ORIGINATION FORM

Proposed Revisions to a Standard Plans Index

Index Number: 455-400

Index Title: Precast Concrete Sheet Pile Wall
(Conventional)

SECTION THRU BULKHEAD
(Showing Plastic Filter Fabric)

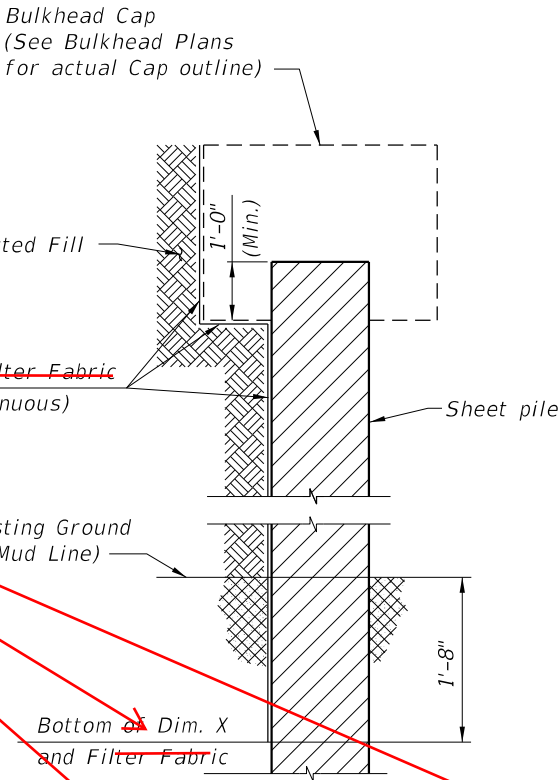
PLASTIC FILTER FABRIC:
The plastic filter fabric shall extend to the bottom of the "X" dimension.

CHANGED: Geotextile

CHANGED: Provide and install Type D-2 or D-3 geotextile in accordance with Specifications 514. Extend the geotextile to the bottom of the "X" dimension.

Sheet 1: Changed the "PLASTIC FILTER FRABRIC" Note in the SHEET PILE DESIGN CRITERIA AND NOTES to "GEOTEXTILE: Provide and install Type D-2 or D-3 geotextile in accordance with Specifications 514. Extend the geotextile to the bottom of the "X" dimension."; Changed all references of "Filter Fabric" or "Plastic Filter Fabric" to "Geotextile".

SECTION THRU BULKHEAD
(Showing Geotextile)

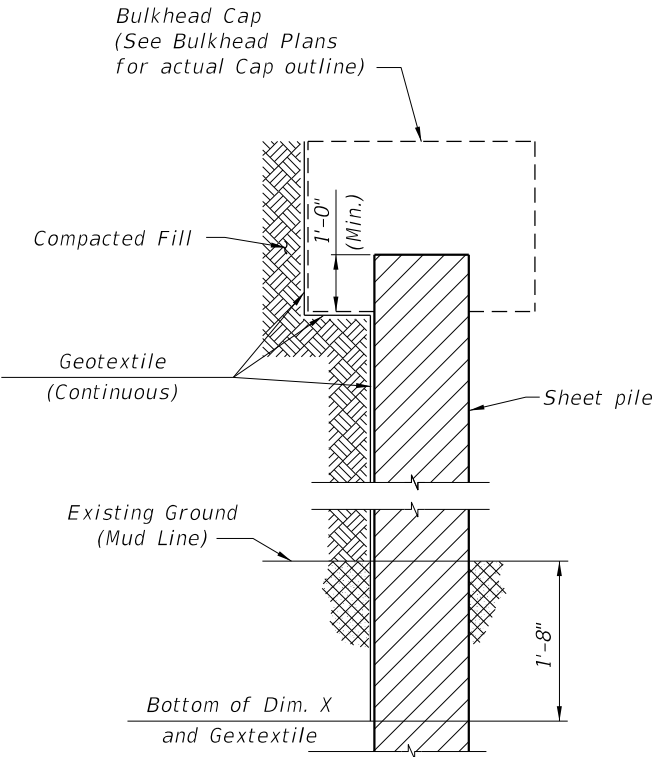
GEOTEXTILE:
Provide and install Type D-2 or D-3 geotextile in accordance with Specification 514. Extend the geotextile to the bottom of the "X" dimension.
